Project	IEEE 802.16 Broadband Wireless Access Working Group < http://ieee802.org/16 >	
Title	Channel Quality Information (CQI) Report for Mobility Support	
Date Submitted	2004-01-02	
Source(s)	Chulsik Yoon, Jaeheung Kim, Kunmin Yeo, Soonyong Lim, Byunghan Ryu ETRI 161 Gajeong-Dong, Yuseong-Gu, Daejeon, Korea	Voice: +82-42-860-6826 Fax: +82-42-860-6732 mailto:csyoon@etri.re.kr
Re:	This is a response to a Call for Comments IEEE 802.16e-03/58 on IEEE 802.16e-03/07r5	
Abstract	This document contains proposal to report the Channel Quality Information (CQI) for mobility support.	
Purpose	The document is submitted for review by 802.16e Working Group members.	
Notice	This document has been prepared to assist IEEE 802.16. It is offered as a basis for discussion and is not binding on the contributing individual(s) or organization(s). The material in this document is subject to change in form and content after further study. The contributor(s) reserve(s) the right to add, amend or withdraw material contained herein.

CQI Report for Mobility Support

2. Proposed changes on IEEE 802.16e-03/07r5:

Figure 1. Example of Current REP-REQ/RSP Procedure

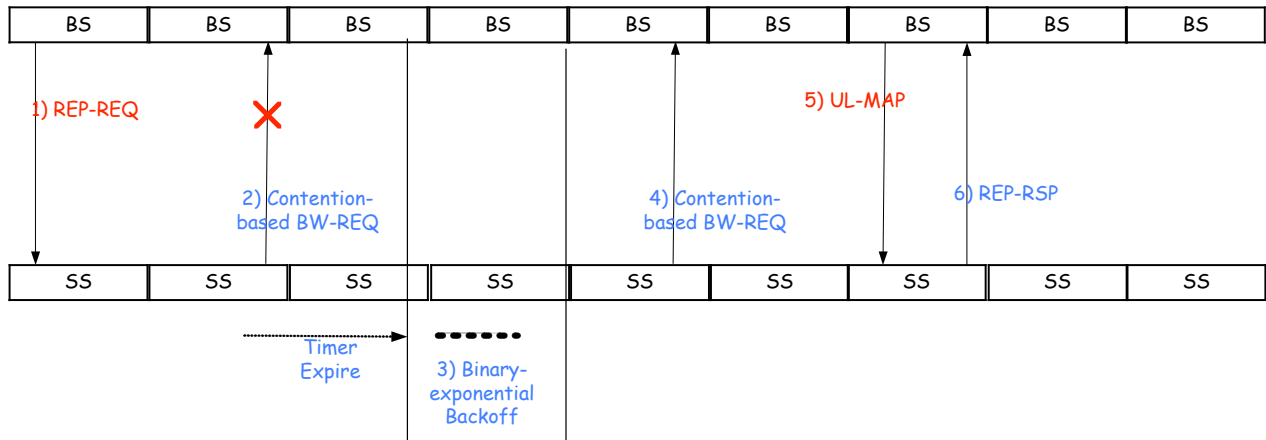
Due to the current REP-REQ/RSP procedures, a BS transmit the REP-REQ message to a specific SS on the basic connection of that SS which is needed to report the channel measurement information, then the SS should respond with REP-RSP message with average and standard deviation for CINR or RSSI. But, when the BS should request to several SSs in the certain frame, the signaling overhead may increase by transmitting the same kind of message to a different SSs. And the REP-REQ message cannot provide any information or assignment of resources to the SSs to transmit the REP-RSP message. Therefore, in general, the SSs should try random access to request the bandwidth to transmit the REP-RSP. That causes some unwanted delay and the channel measurement information may be of no use to reflect the channel situation to adapt the appropriate AMC (adaptive modulation and coding) to the SS in a mobile environment. If we assign the uplink resources by using the UL-MAP-IE() to the SSs which are requested by the REP-REQ, then the UL-MAP signaling overhead will be significant due to the resource allocation to the SSs individually.

As we described in the Figure 1 and Figure 2, the original concept of the REP-REQ/RSp procedure cannot guarantee the on time report of the REP-RSP, but the proposed concept can provide the channel measurement report in the frame.

Figure 3. Example of Proposed CQI Channel Allocation and REP-REQ/RSP Procedure in OFDMA-PHY

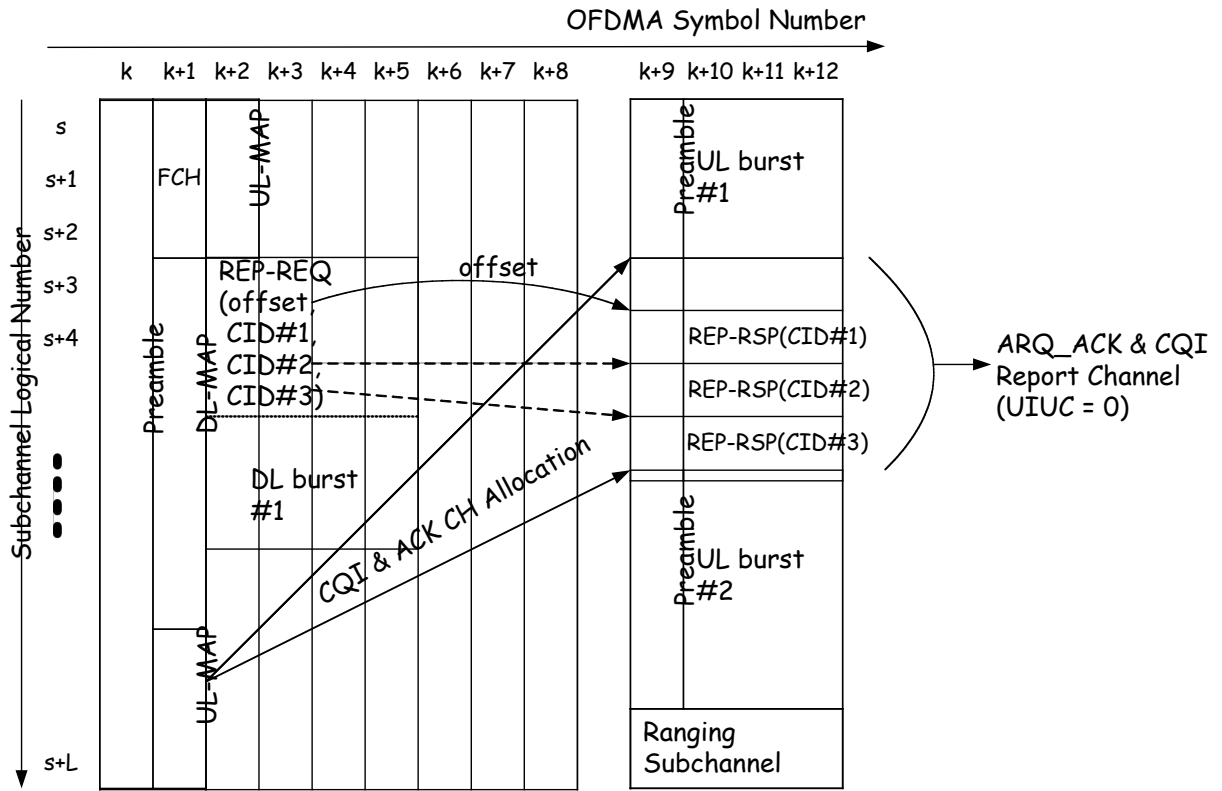
In the Figure 3, we describe the above concept: By using the UL-MAP_IE(), allocate the dedicated uplink resources to a ARQ ACK and CQI channel. REP-REQ message contains the basic CIDs of the SSs which are required to report the channel measurement, and slot offset information which will be the allocated resource

for the first SS in the basic CIDs list. Since the uplink resources to transmit the REP-RSP message information are fixed, the next SS in the CIDs list should transmit the next uplink resources, and so on. Then the UL-MAP signaling overhead can be saved and the on time report of the channel measurements for applying AMC can be achieved.
